# Access Compliance Report

## Public Rights-of-Way

### (Curb Ramps)

Intersection ID: 50596	Main Street: STREAM_ORCHID_LN	Cross Street: GRAY_WILLOW_RD	Location: SE
ADA ID: 8AEB350BBACD	Ramp Type: Perp	Initial Pass/Fail: Fail	Overall Compliance: No
Severity Score: 22.5			
Codes/Mitigation Info/Possible Solution		Field Measurements/Component Compliance

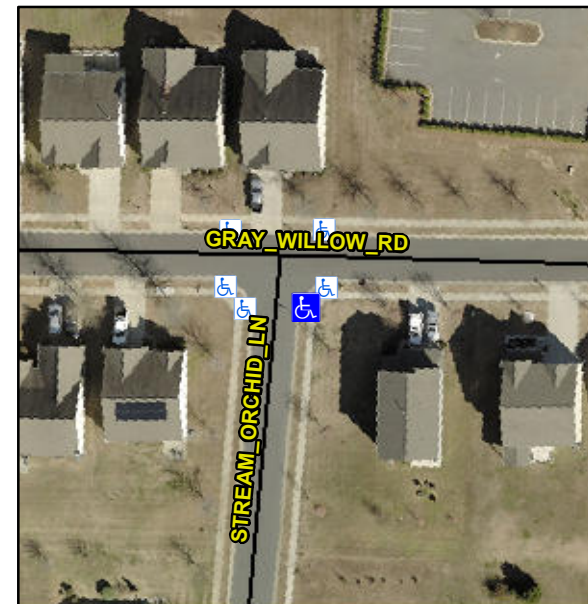
**Not Found, R304.5.1, R304.2.2, R304.5.3**

Compliance	Description	Data	Compliance	Description	Data
N/A	Ramp Length (in)	49.0	No	Ramp Slope (%)	9.6
No	Ramp Width (in)	47.5	No	Ramp XSlope (%)	2.8
N/A	Flare Type LT	N/A	N/A	Flare Type RT	N/A
N/A	Flare Slope LT (%)	N/A	N/A	Flare Slope RT (%)	N/A
N/A	Flare Traversable LT?	N/A	N/A	Flare Traversable RT?	N/A
N/A	Landing Length (in)	N/A	N/A	DWS Provided?	N/A
N/A	Landing Width (in)	N/A	N/A	DWS Contrast?	N/A
N/A	Landing Slope (%)	N/A	N/A	DWS Length (in)	N/A
N/A	Landing X Slope (%)	N/A	N/A	DWS Full Width?	N/A
N/A	Landing Curb? (Y/N)	N/A	N/A	DWS Offset (in)	N/A
N/A	Shared Landing?	N/A			
N/A	Gutter Ponding?	N/A	N/A	Gutter Slope (%)	N/A
N/A	Gutter Lip Ht (in)	N/A	N/A	Gutter X Slope (%)	N/A
N/A	Painted X Walk1?	No	N/A	Painted X Walk2?	N/A
	X Walk 1 Direction	To W		X Walk 2 Direction	N/A
N/A	X Walk 1 Width (in)	N/A	N/A	X Walk 2 Width (in)	N/A
	X Walk 1 Slope (%)	1.4		X Walk 2 Slope (%)	N/A
	X Walk 1 X Slope (%)	2.6		X Walk 2 X Slope (%)	N/A

**Remove & Replace Entire Ramp.**
